This is a revision of Outboard Service Bulletin 89-16. Destroy Bulletin 89-16 and insert Bulletin 89-16A. Revisions are underlined.

- A. Excessive Throttle Force – Mariner/Mercury 135 thru 200
- B. Carburetor ANti-Icing Kit – Mariner/Mercury 70/75/80/90 and 100/115
- C. Control Handle – Remote Control P/N 88150A7, A8, A9, A11, A15, A17
- D. Lean Idle Mixture – Mercury 275
- E. Cracked Flywheel Hub – Mariner/Mercury 250 and Mercury 275
- F. Oil Tank Vent – Mariner 40 Magnum and Mercury 40 Electric Start

Figure 1.

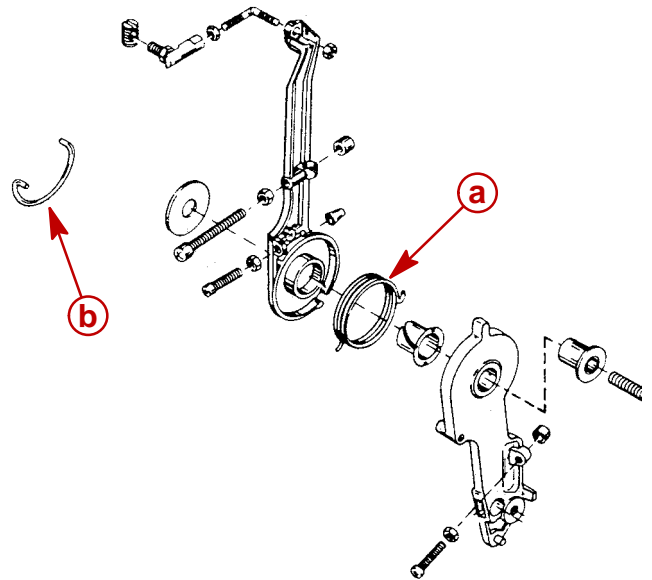
On 1989 and previous Mariner and Mercury 135–200 models replace existing throttle spark lever spring with spring with less tension and remove throttle return spring (Figure 1).

24–68784 24–551 62 Throttle 'Spark Lever Spring
24–41050 Remove Throttle Return Spring

Figure 2.

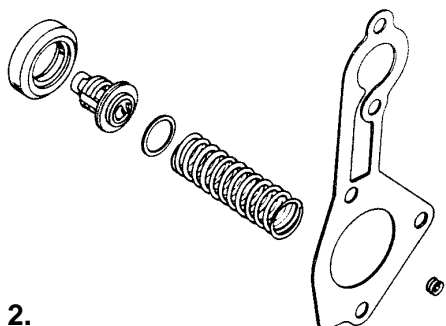
A kit to increase cylinder block temperatures and help prevent carburetor icing is available. Kit should not be installed on outboards that operate in water above 50° F (12.2°C) or overheating will occur.

P/N 75692A12 Carburetor Anti-Icing Kit

Figure 3.

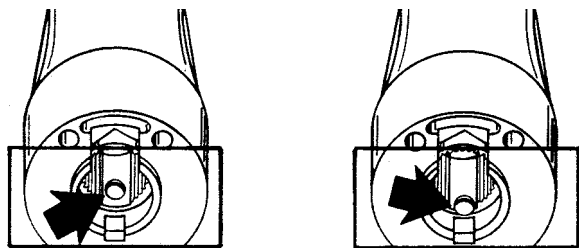
It has been brought to our attention that the set screw which secures the handle to the center shaft of the control is pushing the handle back away from the control bezel. This may allow the handle, after a period of time, to miss the lock slot in a neutral position at the cam on the control module. When the set screw hole is drilled at the wrong angle the screw will push the handle back away from the lock ring and the handle may not lock out in the neutral gear position. If so, replace handle with a new one.

Qty 1 P/N 88314T Control Handle
One half (0.5) hour labor

Figure 4.

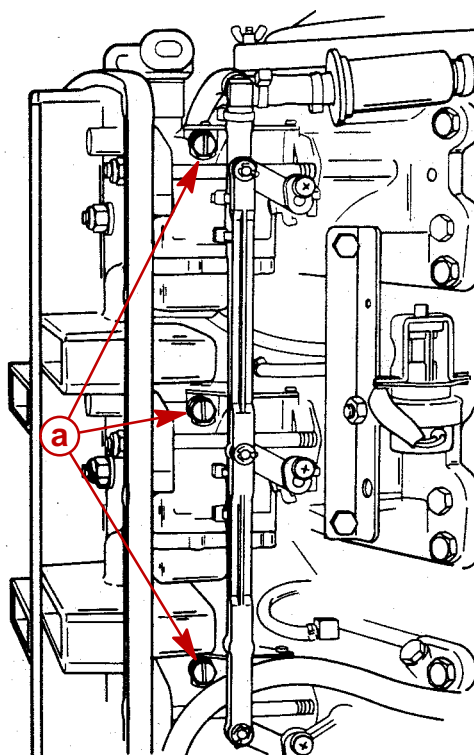
Replace existing .058 idle jets with larger .060 idle jets to correct rough idle due to lean fuel mixture. Models listed require idle jet change.

Idle jets are easily replaced on port carburetors (Figure 4) by removing access plugs. Sound attenuator plate and cover must be removed to replace idle jets on starboard carburetors.

Qty 6 P/N 1395-6487 .060 jet 10-32 thread

Mark each idle jet access plug with a black mark. Idle jets have been changed in production after serial number listed and access plugs will be marked.

Figure 5.

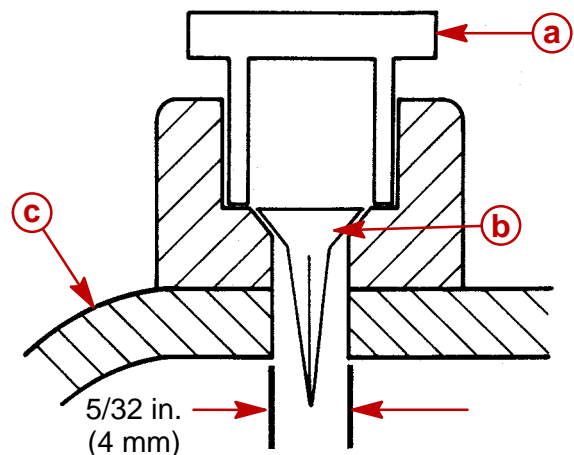
Oil tank collapse during operation may be caused by vent hole that was not drilled properly on models listed.

Remove oil tank vent cap and duck bill check valve. Oil tank vent hole must have opening of 5/32 in. (4mm) diameter (Figure 5) into oil tank. A smaller opening in the oil tank vent hole may cause the duck bill check valve to not function properly. Replace oil tank if vent hole is smaller than specified.

Qty 1	P/N 1264-812778A1	Oil Tank Assembly (replacement)
One (1) hour labor or 0.3 hour labor (inspection only)
